APPLICATION NO: 21/02785/FUL		OFFICER: Mrs Emma Pickernell
DATE REGISTERED: 22nd December		DATE OF EXPIRY : 16th February 2022
2021		
WARD: Prestbury		PARISH: PREST
APPLICANT:	Duncan Rawlings	
LOCATION:	23C Finchcroft Lane Cheltenham Gloucestershire	
PROPOSAL:	Demolition of existing single storey dwelling and erection of new two storey dwelling

REPRESENTATIONS

<> (contour land profile submitted)

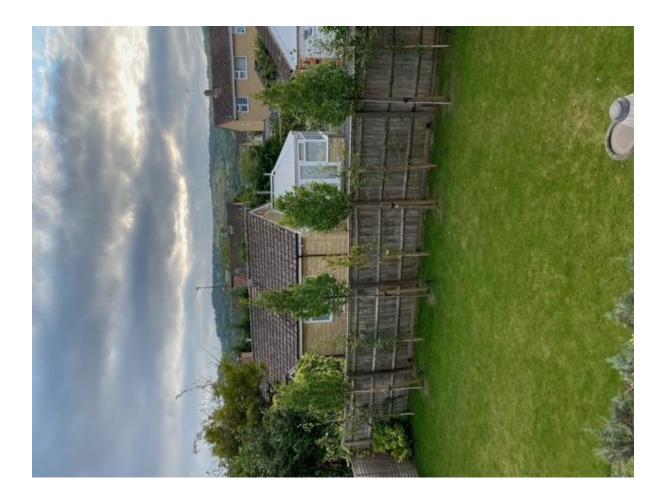
NOTE The plans ('proposed context sections') showing the 25 degree sight lines are inaccurate and do not show the full extent to which our property and garden will be overlooked where actual representation of the topography would reflect that our garden slopes downwards from the 23c boundary hedge. The current 23c property is c10m from our main living room at the back of our house and, although located at the end of our garden, maintains some privacy due to it being at a single level and around the height of mature shrubs. This planning proposal is a massive overdevelopment of a relatively small plot surrounded on all sides by properties in very close proximity, who will be adversely impacted in multiple ways. This has been previously acknowledged when the Planning Committee refused a much smaller scale planning extension to the garage as affecting the occupants of the neighbouring property "unduly overbearing and oppressive". The Parish Council have also noted "concern over neighbours' amenity" in a planning proposal for this property. (contour land profile submitted)

* Creating unacceptable overlooking: Due to the increase in height of the development, within close proximity to our house, we would lose the enjoyment we get from being in our largely private garden and the privacy that we currently have in the rooms at the back of the house. Our outdoor eating area is c9m away and faces the existing 23c tiled roof-line. If this roof is to be replaced by the proposed first floor double balconies, it will result in direct and complete overlooking of this area and an obtrusive invasion of the privacy we currently enjoy when dining out and enjoying our garden. (photo submitted).
